Summary Report
Nuclear Criticality Re-analysis
for 4.3 Weight Percent U-235 Fuel
In the New Fuel Storage Rack of
the Joseph M. Farley Nuclear Plant

SUMMARY REPORT
NUCLEAR CRITICALITY RE-ANALYSIS
FOR
4.3 w/o FUEL
IN
NEW FUEL STORAGE RACK
OF
JOSEPH M. FARLEY NUCLEAR PLANT
OF
ALABAMA POWER COMPANY

Revision 1 - March 21, 1984

UAI DOCUMENT REVISION NOTICE

FIGURE 5

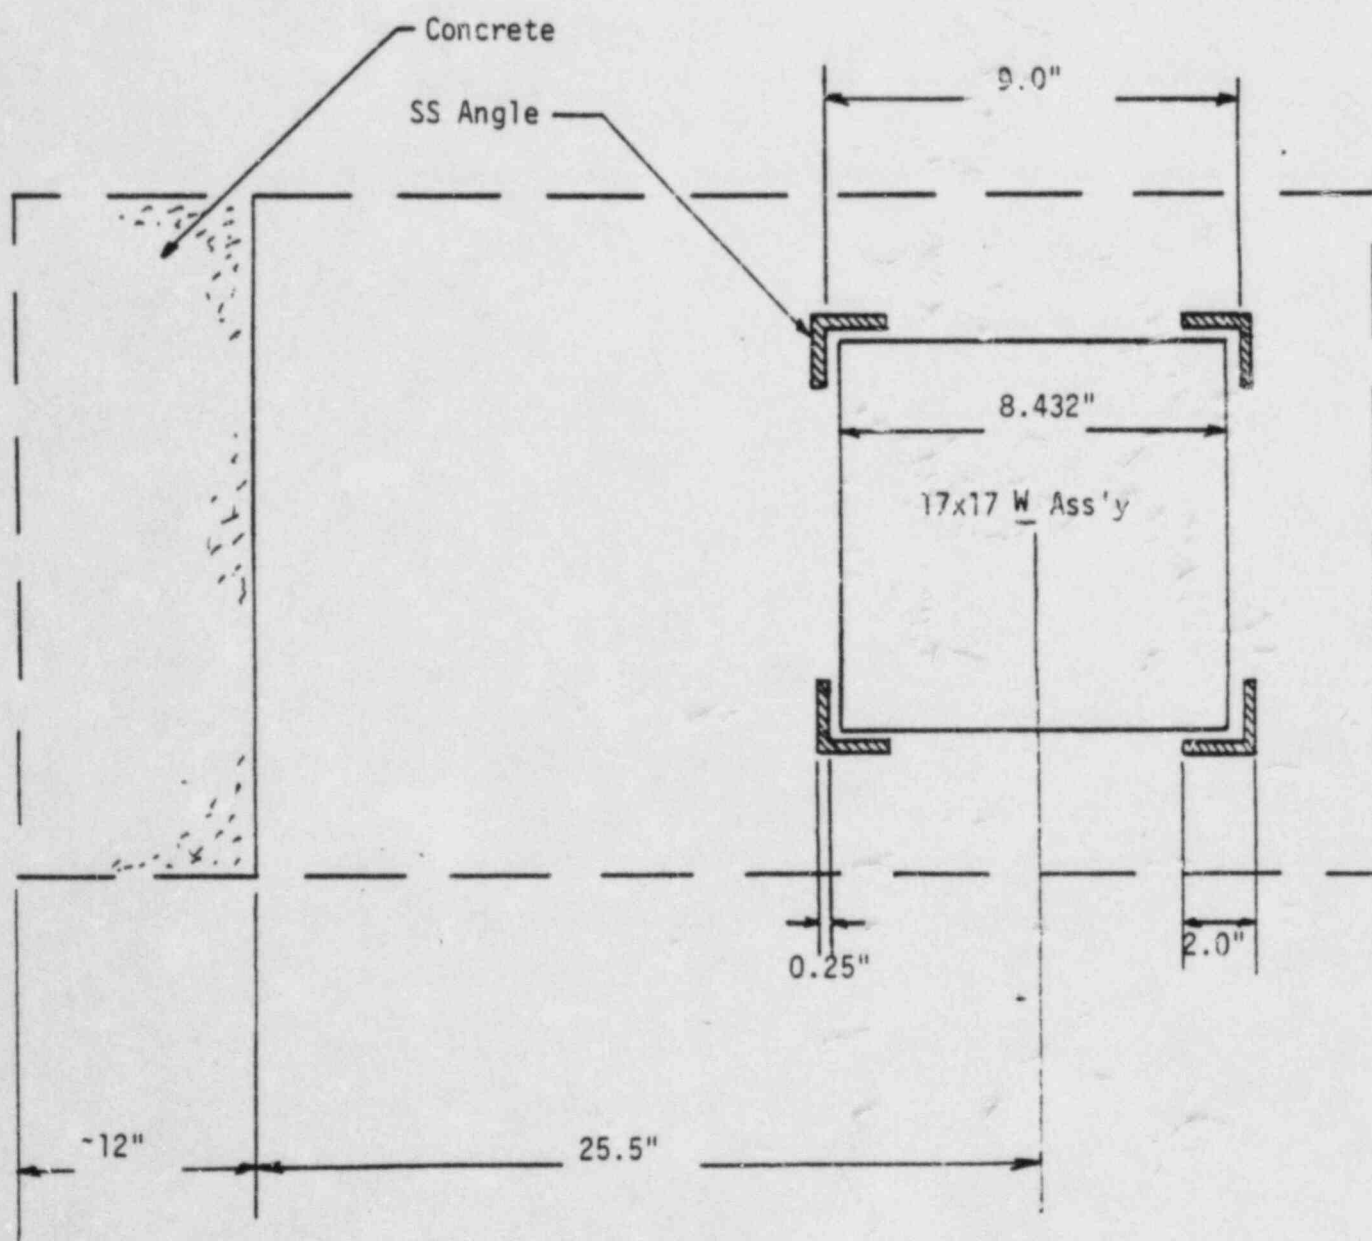
<u>Page Number</u>	<u>Status</u>	<u>Comment</u>
6-1	Revised	Editorial, add detail on criteria
7-1	New	Add references
Figure 5	Revised	Add concrete dimension

In the KENO-IV calculation, each fuel and water rod cell is represented discretely. The array option of KENO-IV is applied to arrange the fuel and water rod box types into a matrix representing the fuel assembly. Then a water region is added to the outside of this matrix, followed by stainless steel angles in each corner, an outer water gap region, and a concrete region on one side of the storage rack cell. To simulate the arrangement of two storage rack units wide and a large number of storage rack units long, and for a non-leakage condition in the axial directions, reflection is applied to the five non-concrete sides of this storage rack cell. For the sixth side, the concrete side, a zero flux boundary is applied 12 inches into the concrete. (See Figure 5.)

The reference cases in this report are the KENO-IV calculations in the nominal rack geometry at 2% and 5% water density. The nominal rack geometry is the same as shown in Figure 3 except that the amount of water on one side is increased and bounded by concrete as shown in Figure 5. This water distance to the concrete corresponds to a 25.5" distance from the center of the assembly to the concrete wall.
